ACCESS COMPLIANCE ASSESSMENT REPORT

Building Code of Australia 2022 Amendment 2

PROJECT:	32-34 Kent Street, Belmore
REF. No.:	NEW250719 (Rev 3)
DATE:	23/07/2026
CLIENT:	Multiform D & C
CONTACT:	Mirwan Hanna
EMAIL:	mirwan@multiform.net.au
CONSULTANT:	Mauricio Vera
PHONE No:	0451 078 790
EMAIL	mvera@newcrown.com.au

Identified Principal Pedestrian Entrance

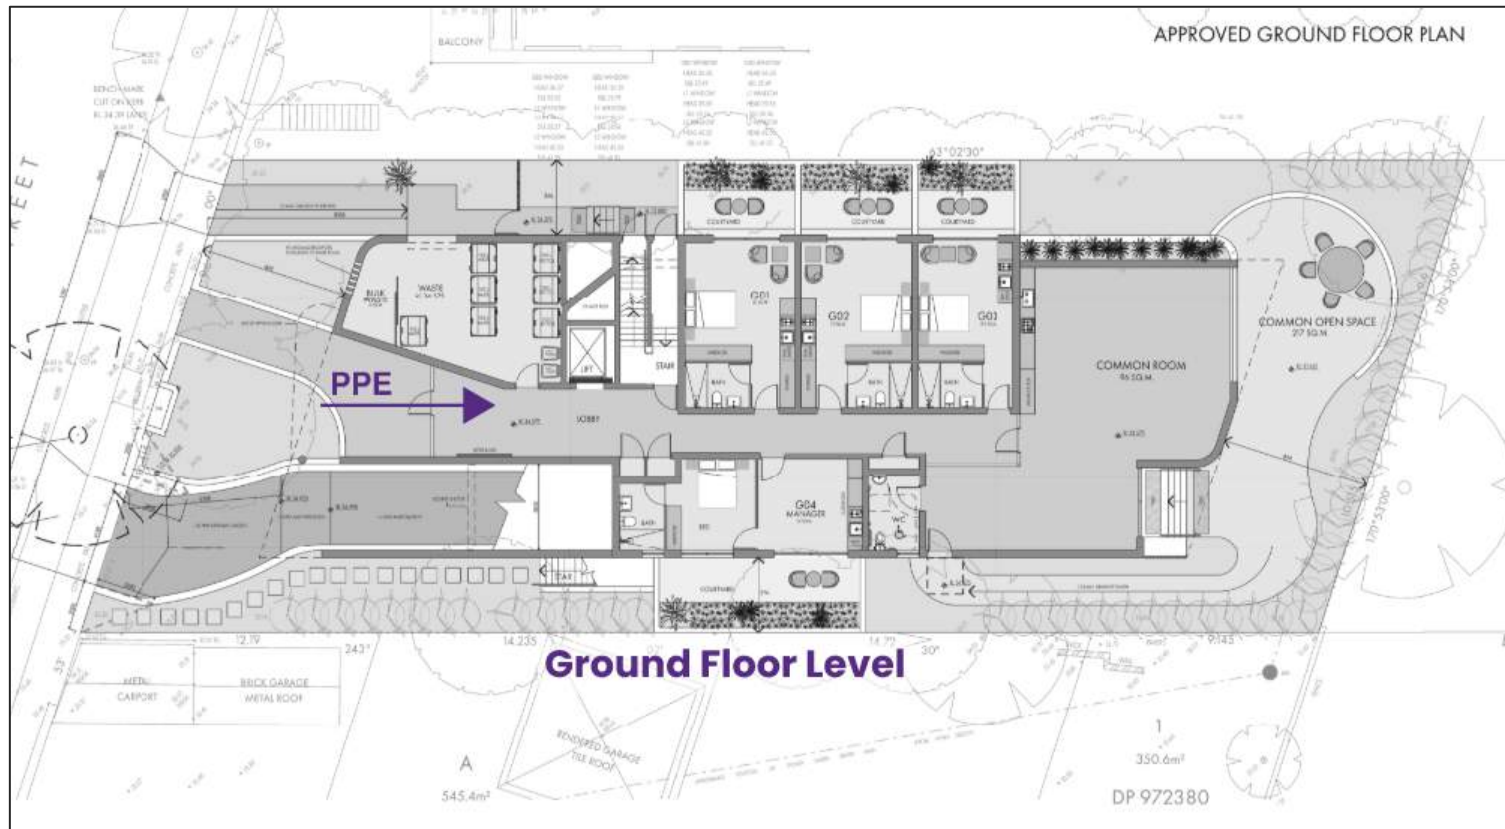
The principal pedestrian entrance of the building is located on Kent Street and is served by a hinged door understood provided with level surfaces on both sides, capable to comply with this clause (Refer to item 7 in relation to doorway circulation spaces).
